Re: Franklin Country Club
Notice of Intent
Response to Comments
DEP File No. CE 159-1319
Project No. 25-001

On behalf of our client, Franklin Country Club, Avalon Consulting Group, LLC (Avalon) is pleased to provide this response to comments from BETA Group Inc. (BETA) And DEP CERO Wetlands issued on September 17, 2025 and September 19, 2025. Attached to this letter are:

PART I: RESPONSE TO BETA COMMENTS:

SUBSURFACE INFILTRATION SYSTEM

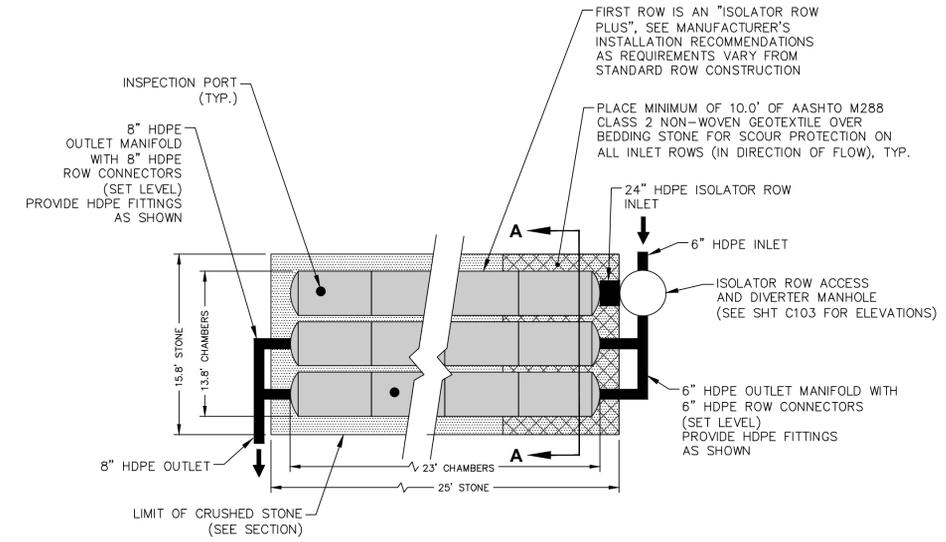
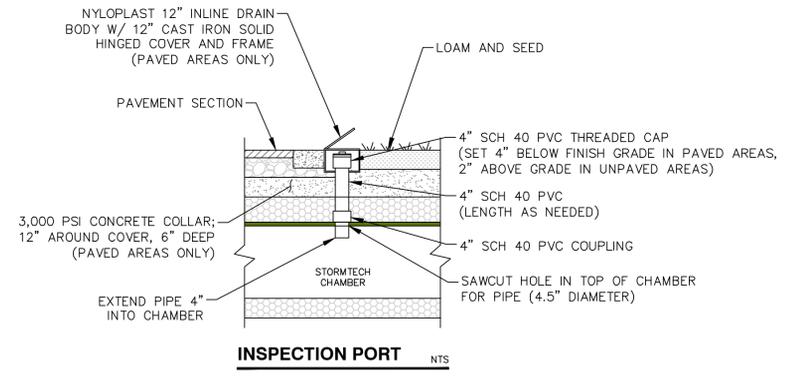
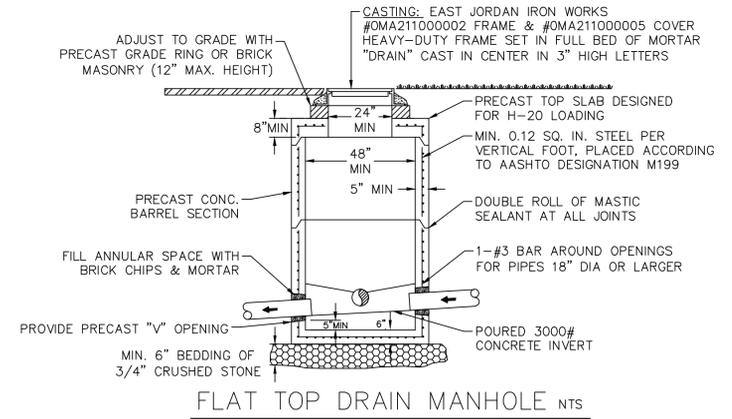
SW4. Provide a soil test within the footprint of the subsurface infiltration system to confirm seasonal high groundwater elevation and soil texture.

SW6. Provide required 44% pretreatment, such as an isolator row (with maintenance access) in the proposed subsurface infiltration system.

Response: The subsurface infiltration system is proposed within the footprint of the existing 5th tee and soil testing has not been completed so as not to disturb the golf course operations. As identified in the system detail on Sheet C502, and as discussed with the Commission on September 18, 2025, confirmatory soil testing for estimated seasonal high groundwater table (ESHGWT) and soil texture will be witnessed by the Design Engineer prior to system installation. Should there not be a minimum 2' separation from the ESHGWT, or if less than 4 ft to the ESHGWT, additional analysis and modified plans will be submitted.

Response: The "Isolator Row Plus" treatment device is proposed due to the presence of a critical area and soils with rapid infiltration rates. This system will remove 80% of TSS prior to discharge to the subsurface infiltration system, in excess of the 44% required.

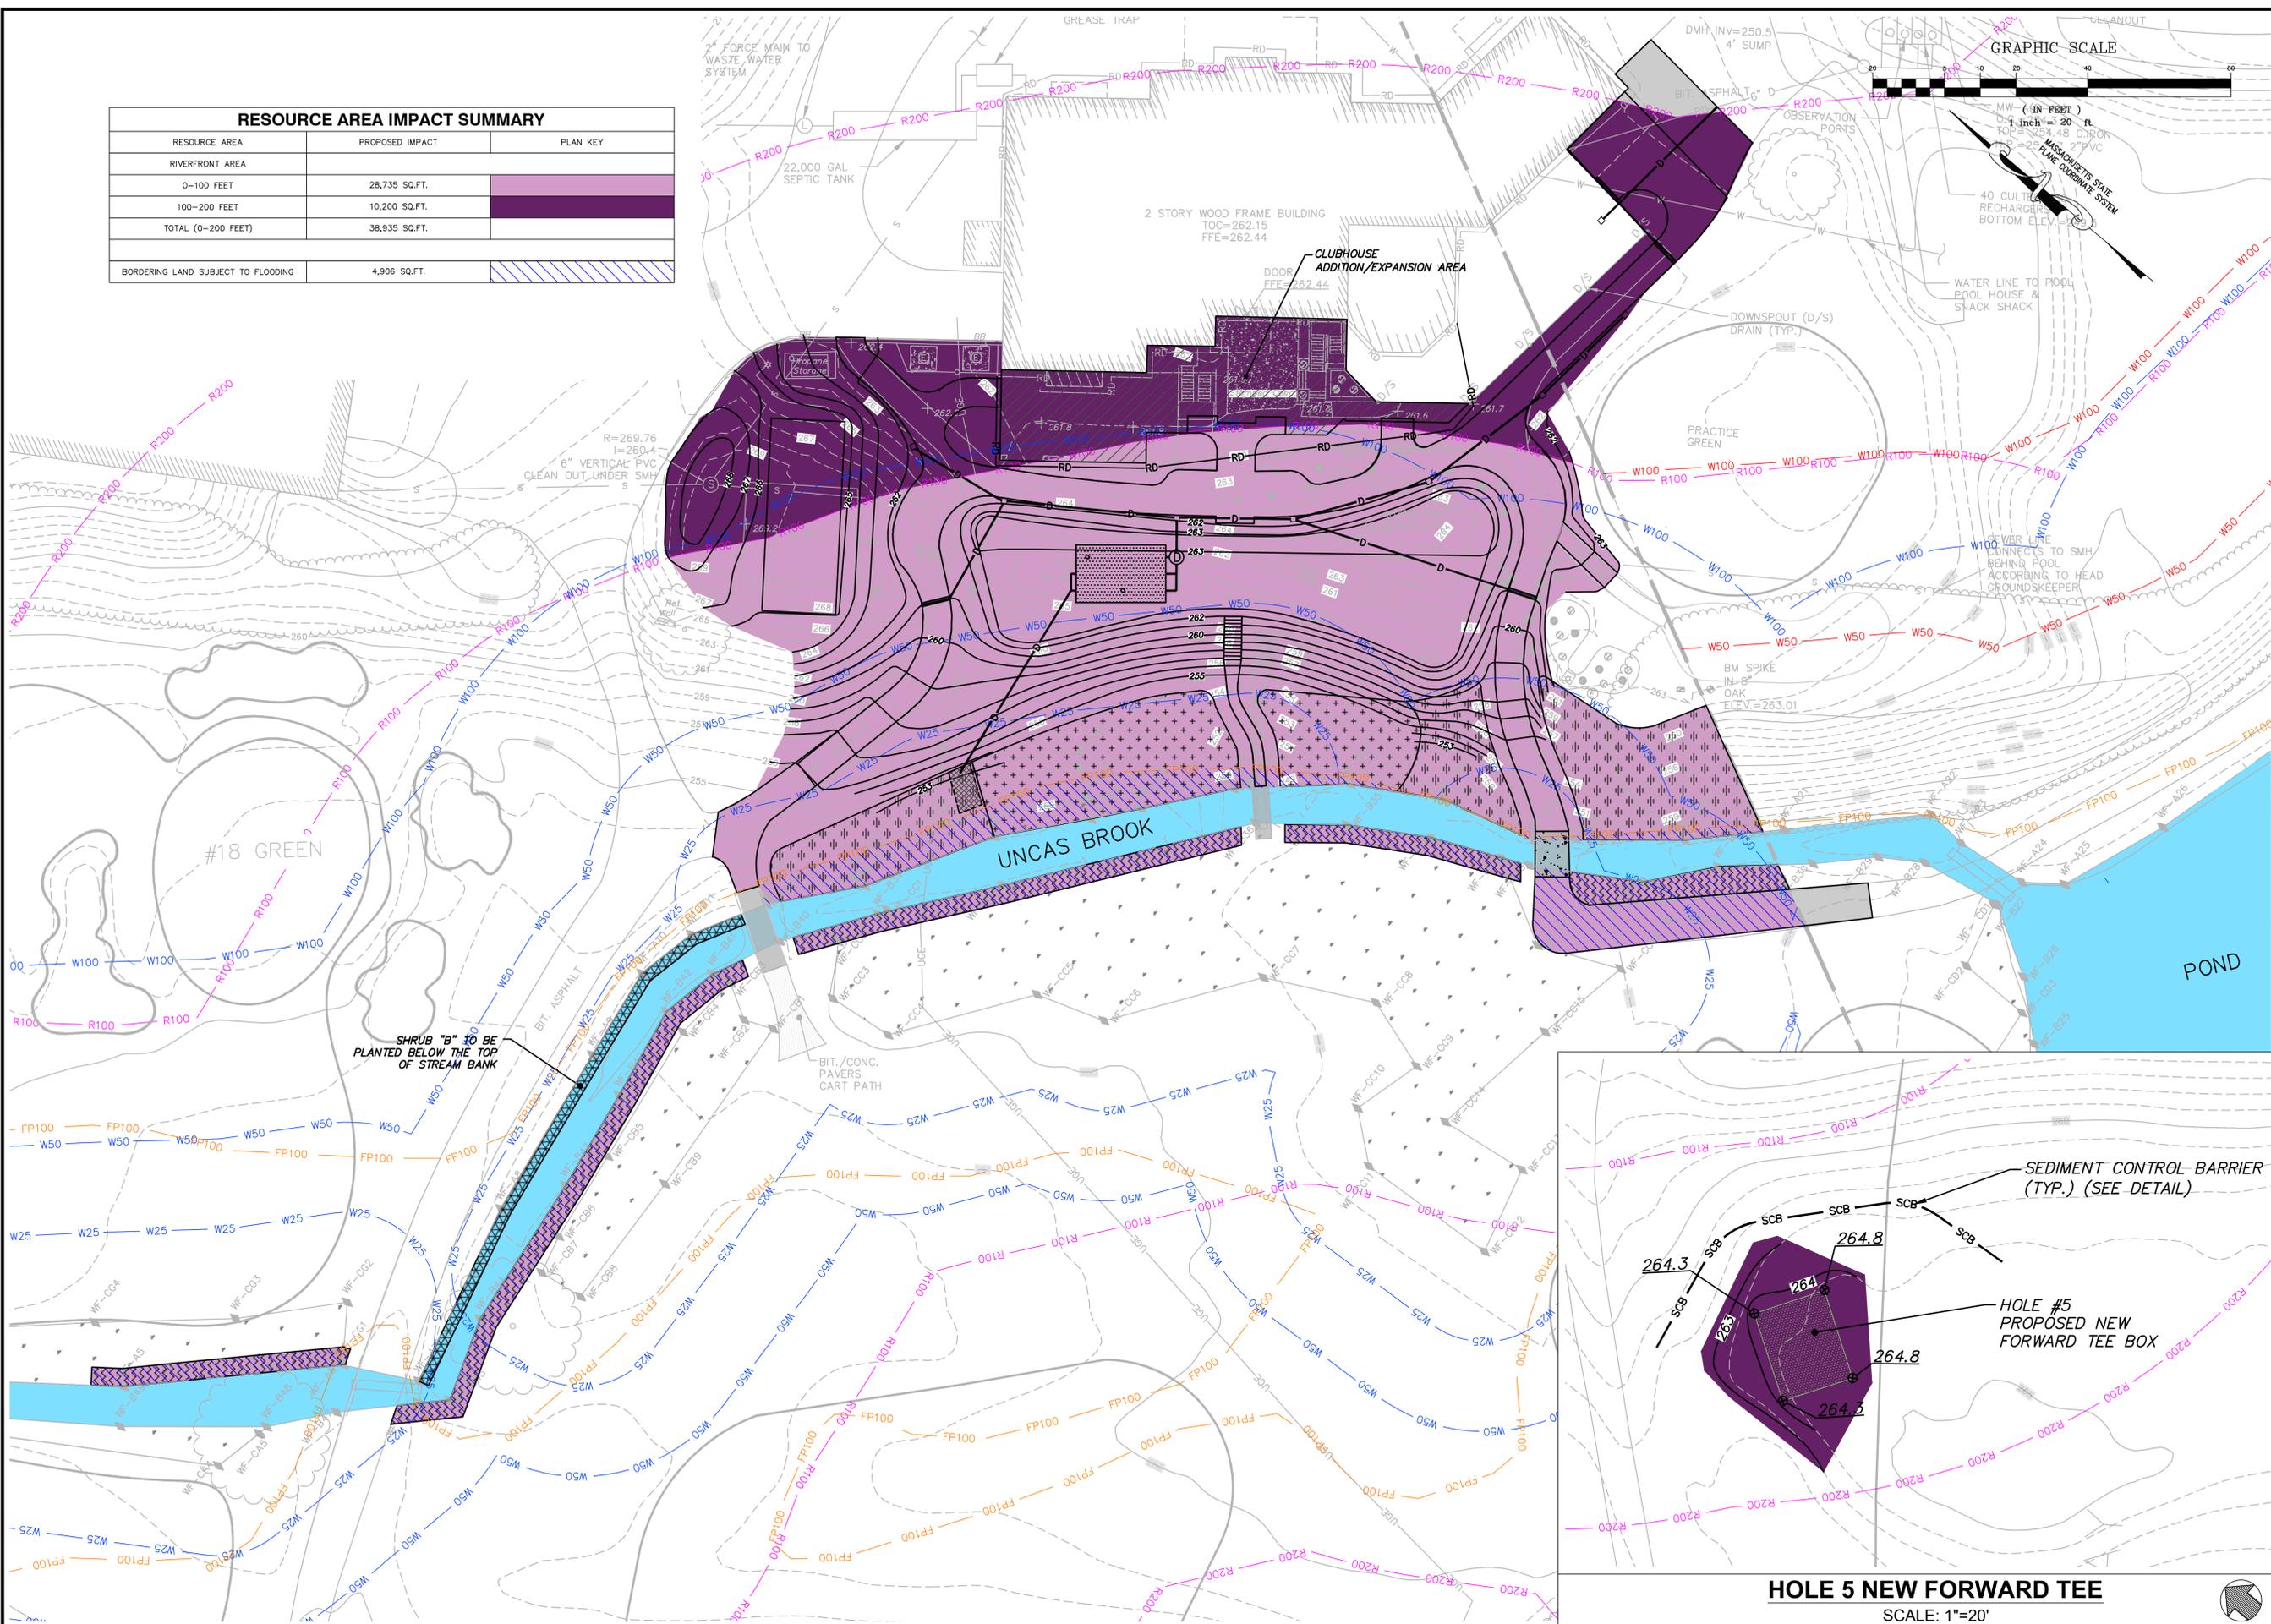
W3. Resource Area impacts (both permanent and temporary) should be clearly labeled on the Project plans.

Response: Resource Area impacts are summarized in a table and called out graphically on exhibits A and B, (Appendix E).
